RE: *Hanover Weston* at 510, 518 and 540 South Avenue, Weston, MA (“Project”)
Responses to Peer Review and Other Comments – Stormwater/Wastewater/Civil

1. EXECUTIVE SUMMARY

Stormwater/Wastewater/Civil

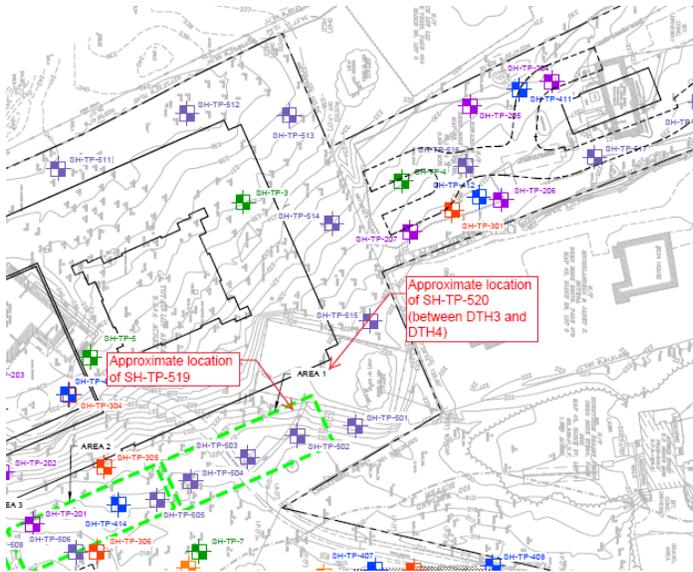
MMA Observation 1: MODFLOW mounding simulations suggests proposed, post - development conditions will create a new mixed groundwater and septic effluent breakout condition (i.e., mounding exceeding local land surface elevation) that would not occur under a comparable, predevelopment scenario.

Davis Issue #3: Lacking Breakout Analysis

It is recommended that the applicant assess breakout in the areas that will be filled, using post-development design elevations. And it is recommended that the applicant assess the potential for groundwater seepage between the retaining wall to the east of the Primary Leach Field and the wetland boundary.

The mounding analysis has been updated to assess groundwater seepage into the wetland. The following changes were made:

- The drain boundary to the east of the site was changed to a constant head boundary coincident with the stream within the wetland and the no flow boundary was expanded slightly so there is no flow west of the stream constant head boundary.
- Small adjustments were made to reflect post-development impervious areas more accurately.
- Stormwater infiltration rates were adjusted to reflect hydrographs accounting for the addition of stormwater storage; and
- Based on subsequent verification model runs, the specific yield of the zones representing the sand and the transition between the sand and the till were adjusted from 0.125 to 0.1 and from 0.1 to 0.08, respectively, to better match the model outcomes with the observed groundwater response to Tropical Storm Ida.

Based on updated model simulations, and assuming a design condition of 80% treated wastewater loading for 90 days plus the addition of a 10-year storm event at day 90 added to the Estimated Seasonal High Groundwater (ESHGW) table, a groundwater seepage face will form at the wetland boundary and will dissipate over a few days' time. This is the same seepage condition predicted by the model for the pre-development condition if Tropical Storm Ida had occurred during seasonal high groundwater.

Conclusion: Under the DEP-required design condition, there is no difference between pre- and post-development conditions at the edge of the wetland. The wetland will continue to function as it has pre-development during the design conditions required by DEP.

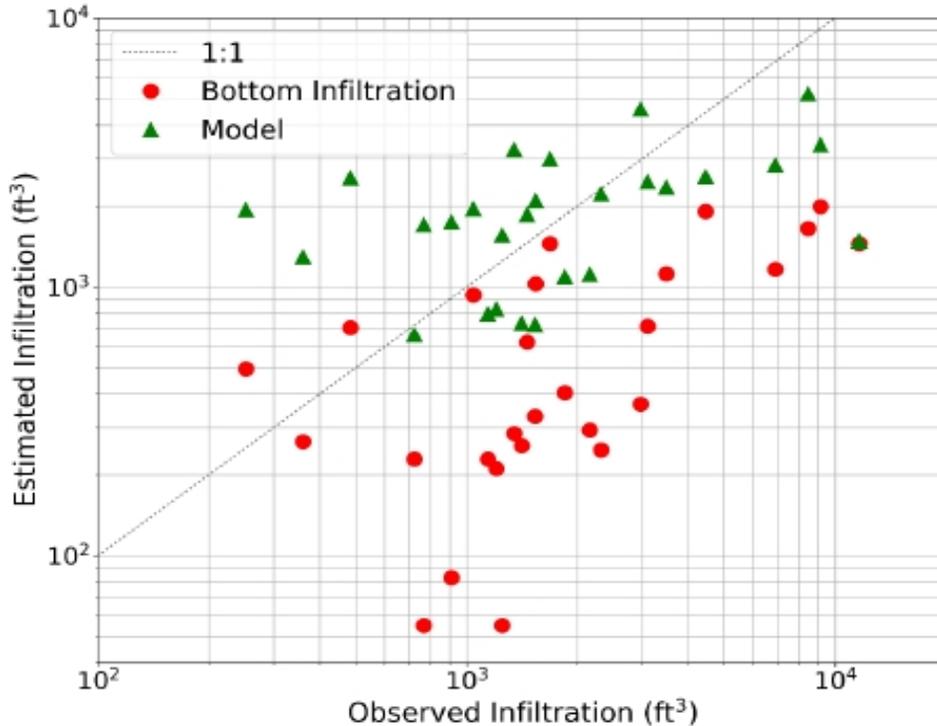
MMA Observation 2: Certain relevant information appears to be excluded in estimating starting groundwater conditions near the proposed stormwater infiltration areas. Including this information suggests the analysis is not successful in demonstrating these areas will function reliably and/or in a manner consistent with how they have been modeled.

Davis Issue #1: Use of ESHGW Data in Analysis

On February 9, 2022, two test pits were excavated by Wellesley Contracting, Inc. in locations shown on the site sketch below. The test pits were observed and logged by Luke Norton, P.E. of Sanborn Head, a certified Soil Evaluator in Massachusetts. The test pits were also

Test pit TP-519 was excavated in the northwest corner of the proposed stormwater infiltration Area No. 1. This test pit encountered soil conditions like other test pits excavated in Stormwater Area No. 1. Groundwater was encountered at 126 inches below grade, or about elevation 212.5 feet consistent with groundwater observations in other test pits and monitoring wells in the stormwater infiltration area. Test pit logs are attached.

Test pit TP-520 was excavated in the former tennis court area between previous test pits DTH-3 and DTH-4 and encountered soil conditions like other test pits excavated in Area No. 1. Further, observations in test pit TP-520 indicated that redoximorphic features and coloration were at the level of buried subsoil associated with tennis court construction, and not estimated seasonal high groundwater (ESHGW). Groundwater was not encountered to a depth of 6 feet.

Previously, the applicant used an ESHGW level of elevation 215.3 for design of proposed Stormwater Area No. 1 based on redoximorphic features observed in test pit TP-503. Test pit TP-503 is located inside the proposed Stormwater Area No. 1 area about 60 feet to the south of the recently excavated test pit TP-519. Soil conditions in test pit-503 were

Conclusion: An ESHGW level of elevation 215.3 feet is still considered the appropriate basis of design for Stormwater Area No. 1.
